**ERRATA for**  
***PE Civil Geotechnical Practice Exam***  
ISBN 978-1-932613-71-1  
Copyright 2014 (October 2014 First Printing)  
Errata posted 8-26-2019

Revisions are shown in red.

**Question 533:**

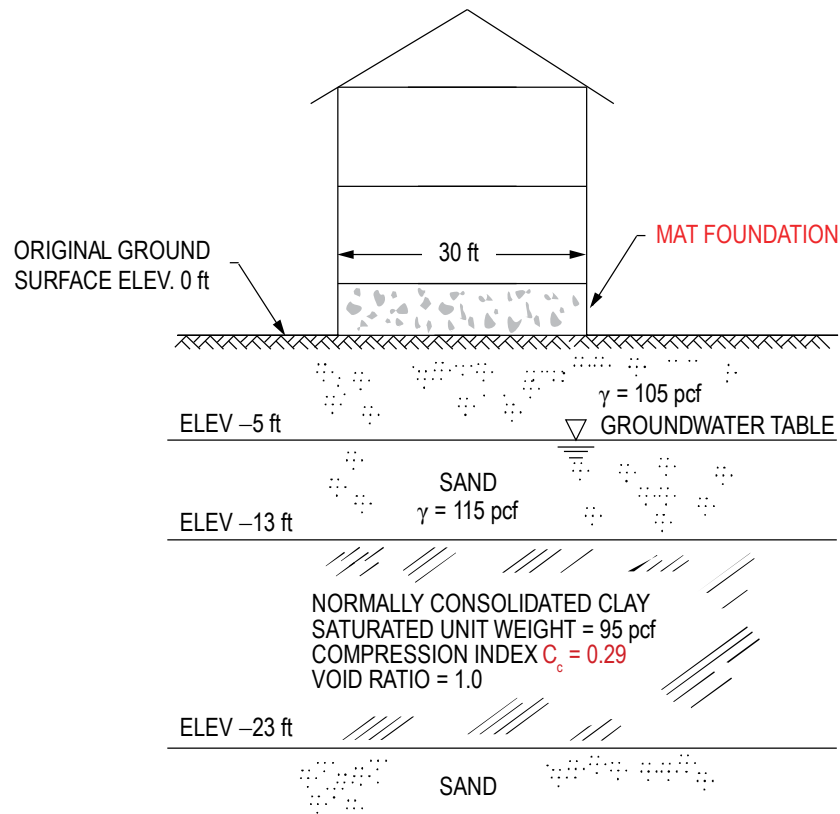
The text and first figure for Question 533 should read as follows.

A 30-ft × 30-ft square mat foundation will be constructed at ground surface. The subsoil profile is shown in the figure. The mat will apply a **net** uniform pressure of 500 psf. Refer to the chart for stress estimation on the following page. The primary consolidation settlement (in.) of the clay layer directly below the center of the mat is most nearly:
